Nebraska Public Power District

Subject: Mark I Containment Long Term Program - Plant Unique
Analysis Report Loads Evaluation.
NRC request for information.

Attached for your review are our answers to the nineteen questions
about our PUAR posed to us in April.

FIGURE 8.1
Torus Submerged Pressure Transient at $z/l = 0.0$ and $\theta = 180^\circ$

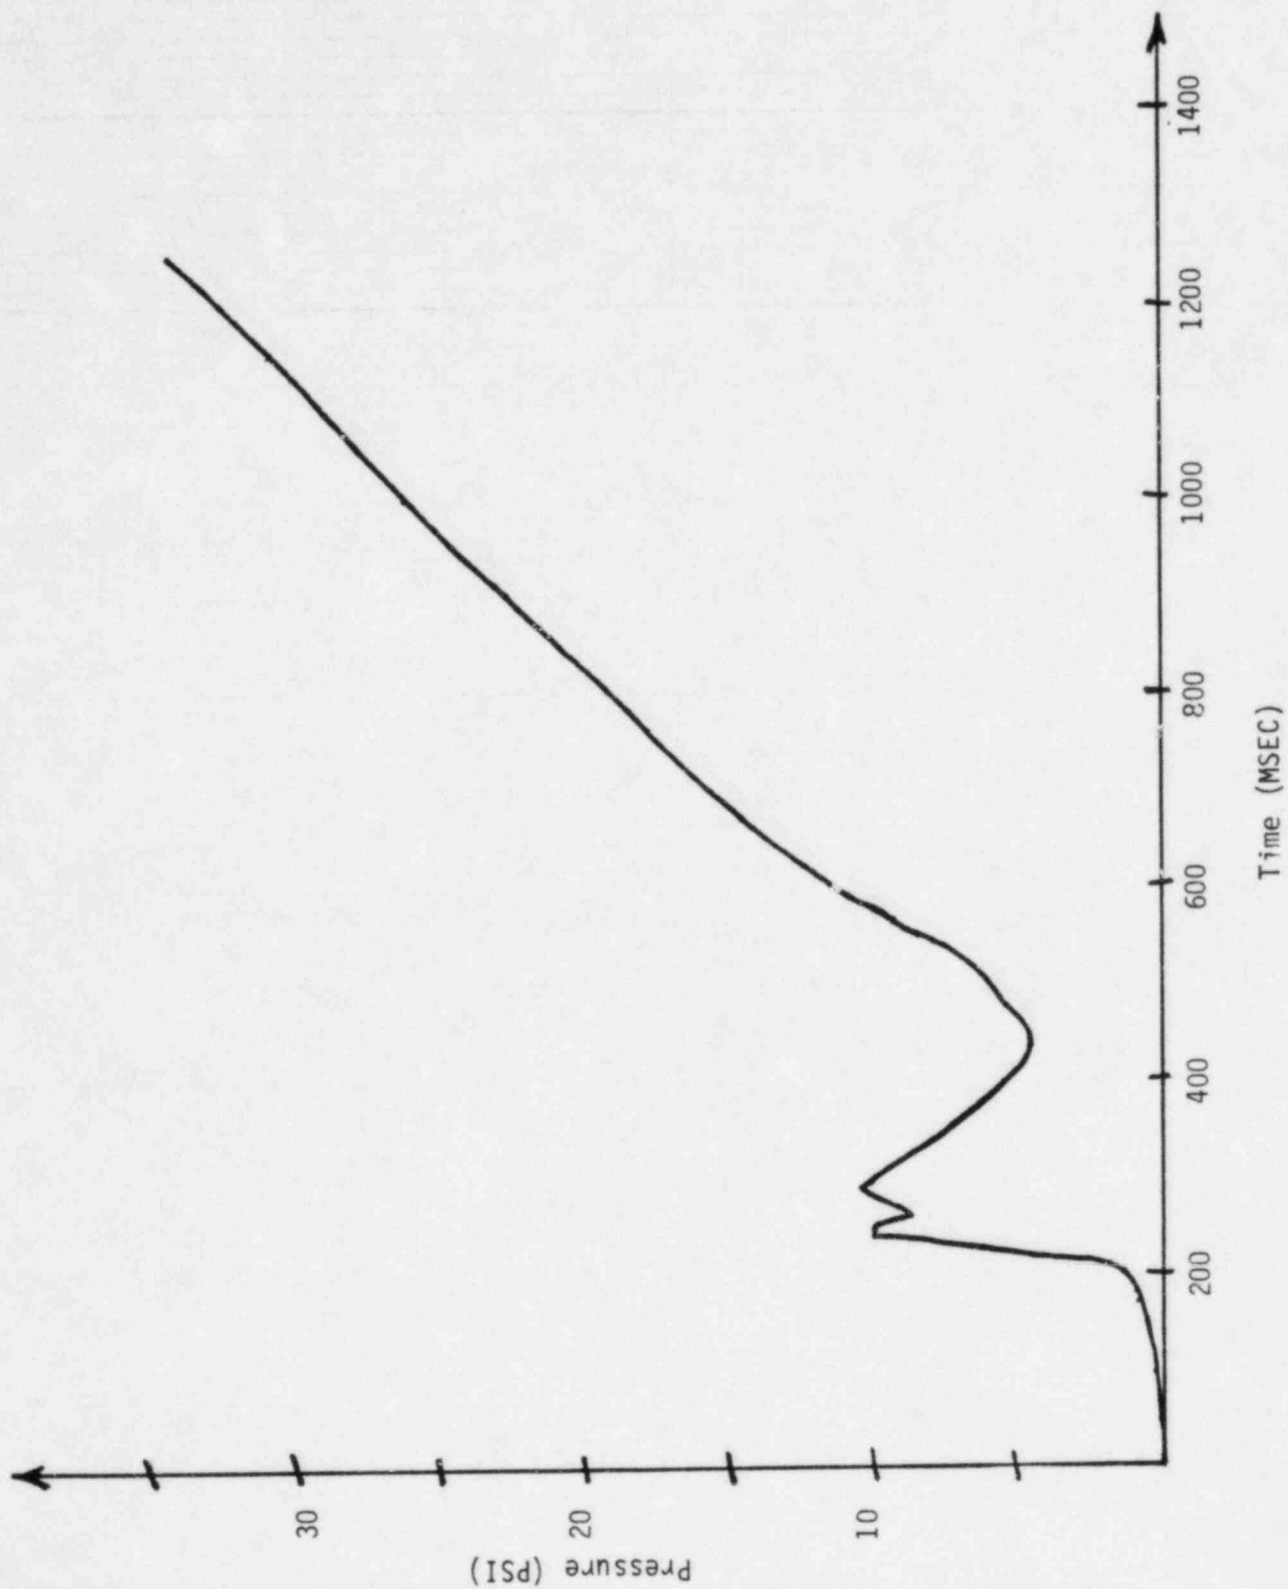
Figure 2.13 in the CNS PUAR shows the corrected torus net vertical loads. Longitudinal and azimuthal multipliers were obtained from LDR Table 4.3.2-1 and were matched to the times corresponding to the events in the load transients in Figure 2.13. For $z/l = 0.0$ and $\theta = 180^\circ$, the following multipliers result for given times:

Figure 2.14 in the CNS PUAR shows the corrected average submerged pressure used with the multipliers shown above to obtain pressure transients at selected locations. The given multipliers were used to obtain multipliers at specific points on the torus by linear interpolation. Multipliers at specific times between the peaks were also obtained by linear interpolation. A computer program was developed to perform these interpolations. The design pressure transients for specific points were obtained by the equation in the LDR:

An example curve for $z/l = 0.0$ and $\theta = 180^\circ$ is attached as Figure 8.1.

FIGURE 14.1
Asymmetric S/RV Discharge Loads

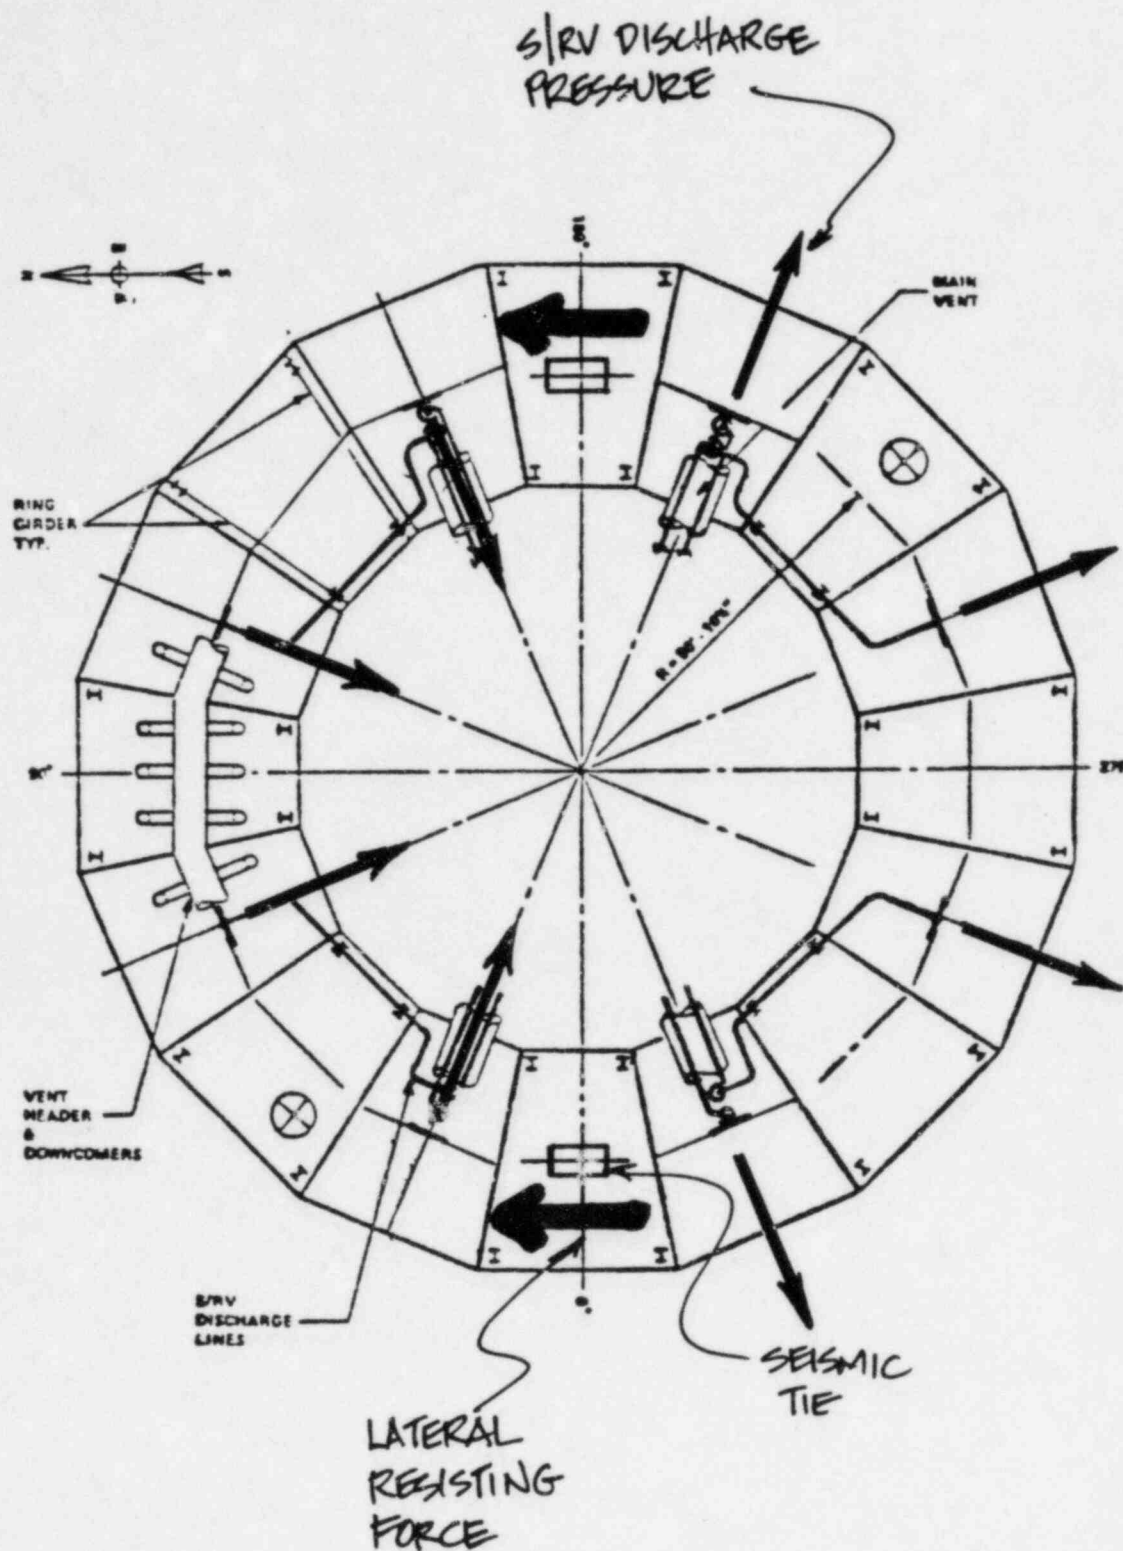
In Section 2.13.7 of the AC, the requirements for consideration of the asymmetric S/RV discharge state that the load case which maximizes the asymmetric condition shall be considered. For CNS, the load condition used for analysis was the actuation of all 8 S/RVs with phasing adjusted such that the horizontal load in one direction would be a maximum.

For the analysis of the torus shell, the ring girders and saddles sufficiently isolate the response of each bay such that the out-of-phase actuation of S/RVs several bays away has an insignificant effect on the response due to S/RV actuation in the bay. The components which are affected by the asymmetric S/RV discharge are the seismic ties, which resist net lateral load on the torus structure. The loads due to the worst-case asymmetric discharge were used in the evaluation of the seismic ties. This worst case involves 4 T-quenchers on one half of the torus discharging such that the pressure load is maximized in the outboard direction in each quencher bay. The 4 T-quenchers on the other side of the torus discharge to maximize the pressure load in the inboard direction. In this way, the net horizontal load on the torus was maximized and used for the seismic tie design. Figure 14.1 illustrates the concept.

FIGURE 19.2
Ring Girder Geometry

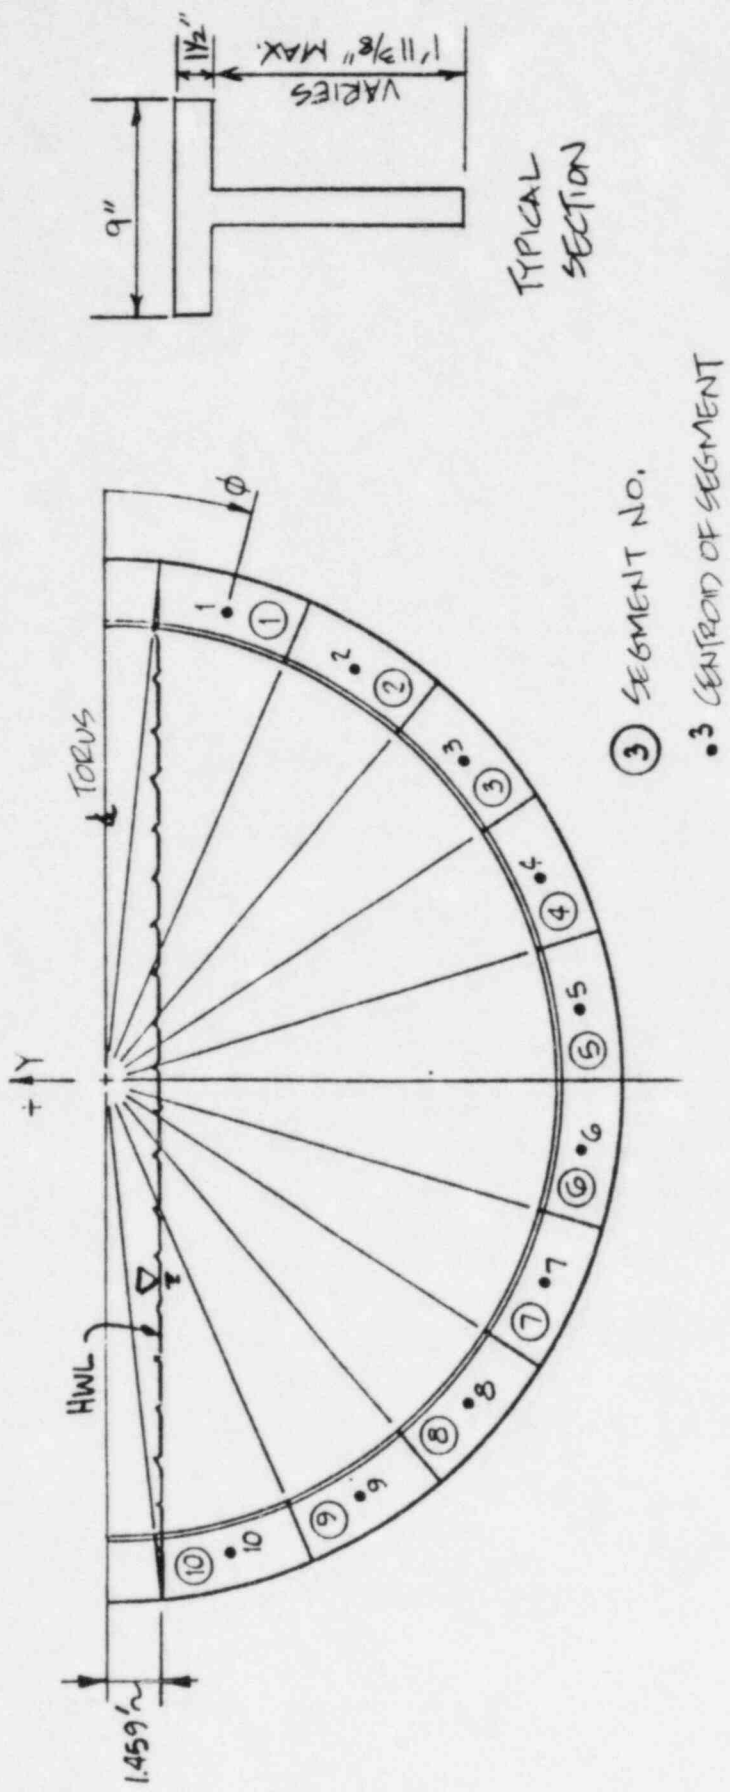
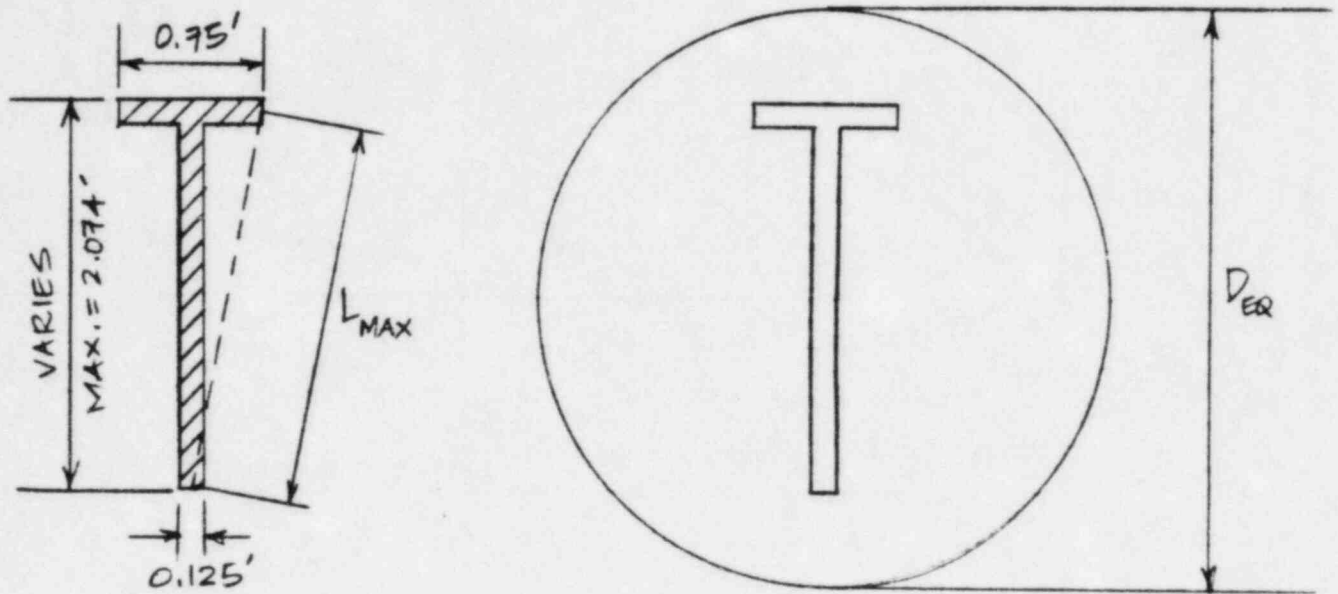
The models used for the development of post-chug loads on the ring girder are shown in Figures 19.1 and 19.2 attached. Vent #1 in Figure 19.1 was the primary vent used for the maximum source and phasing evaluation. Analyses were performed to investigate the effects of phasing between Vents #1 and #2 and Vents #1 and #9 to obtain maximum forces and moments on the ring girder.

The submerged portion of the ring girder was divided into ten segments as shown in Figure 19.2. The drag volume of a ring girder segment was calculated by considering the volume of an equivalent cylinder of diameter D_{eq} as specified in Section 2.14.2 of the AC. Figure 19.3 shows the calculation of the drag volume for the ring girder. The associated drag coefficient used was 2.3.

Figure 19.4
FSI Effects Flow Chart

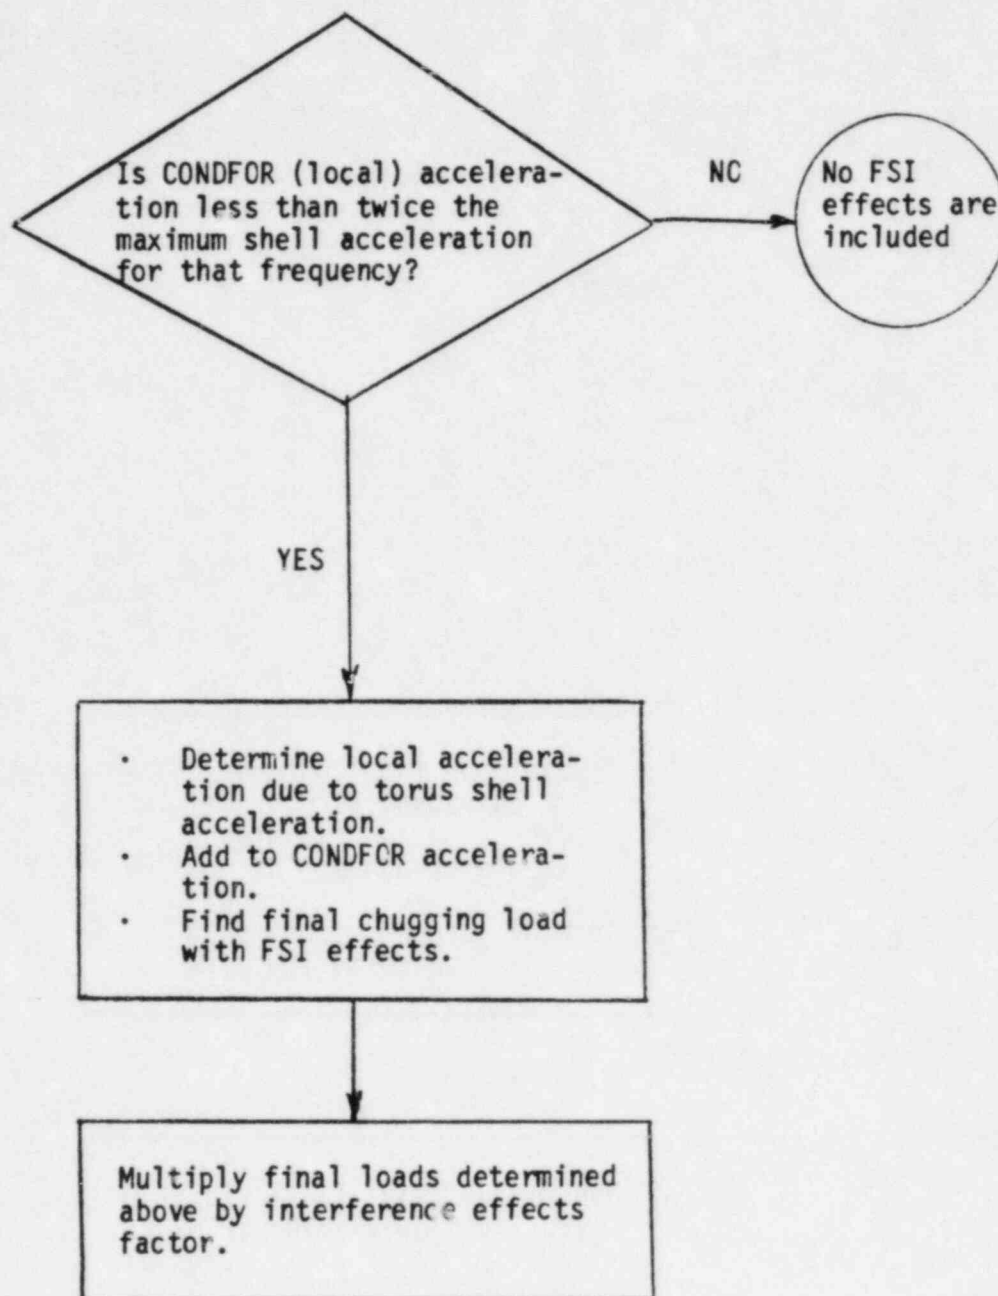
The accelerations at the ring girder segment centroids calculated by CONDFOR were then used to determine the FSI effects on the structure. The FSI calculations were performed using a computer program which used the CONDFOR accelerations, maximum torus shell accelerations, accelerations at the ring girder segment centroids due to torus shell accelerations, and interference effect multipliers to determine the final ring girder design loads. Figure 19.4 shows the flow chart of the program.

The CONDFOR accelerations used are reported in Table 19.2. These accelerations are for the peak source amplitude. The local accelerations for each frequency band were determined by scaling the results of the peak source case by appropriate factors. These were then compared to the maximum shell acceleration determined for each frequency band in the torus shell analysis. FSI effects were included if twice the maximum shell acceleration exceeded the local

(CONDFOR) acceleration. The local effects of the torus acceleration were calculated using the method in Reference 26 of the PUAR, and these accelerations were used to calculate the FSI-induced loads. Interference effects were included as a scale factor applied to the loads. These factors are calculated in Table 19.3.
